## **DETAILED ACTION**

Art Unit: 1795

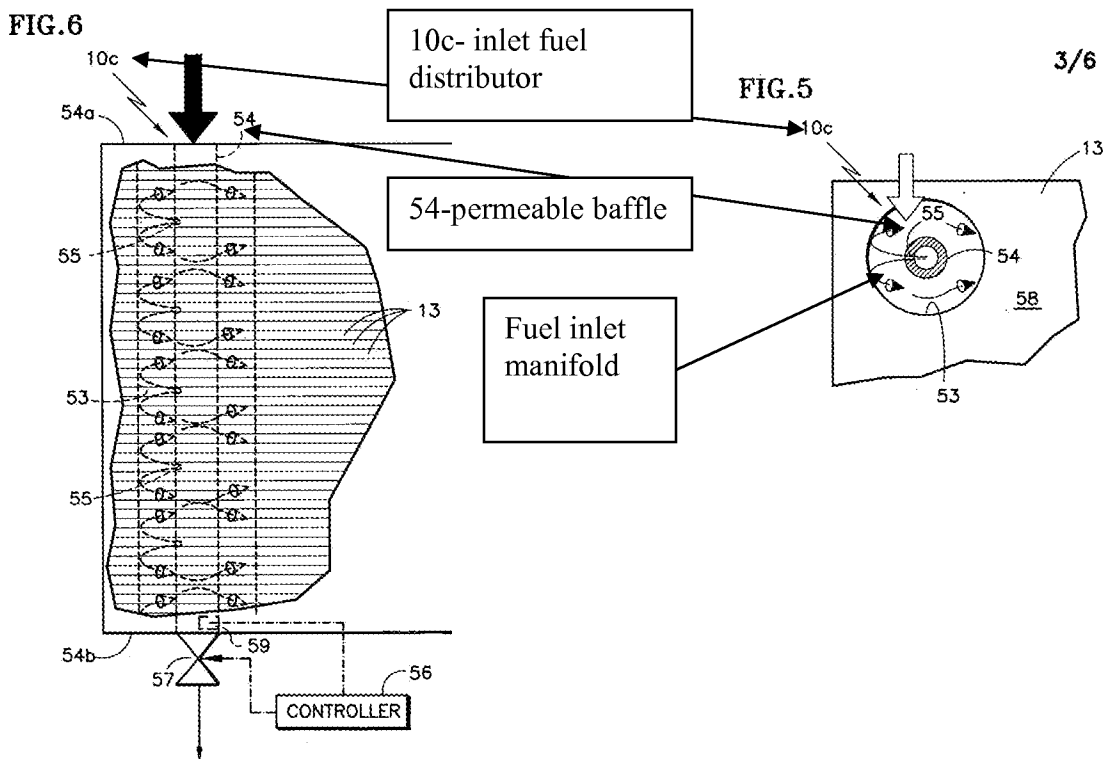
In claims 1 and 14, the claim states “a recycle system for providing recycle fuel from said fuel outlets into said fuel inlet manifold downstream of said permeable baffle”. With reference to figures 5 and 6, the elected species of the fuel distributor, it is unclear how the inlet manifold is down stream of the permeable baffle (see figure below).

The solid dark arrow indicates the inlet of fuel is in the center of the opening of the baffle (54).

The white arrow indicates the recycle fuel enters the system outside of the baffle. Since both fuels (recycled and neat) are entering at the top of the fuel cell, it is unclear how the inlet manifold (53) is down stream of the baffle (54) because the permeable baffle is concentric with the fuel inlet manifold.

For the purposes of examination, the examiner will assume there is a recycle stream which connects the fuel exiting the fuel cells and the inlet of the fuel manifold.
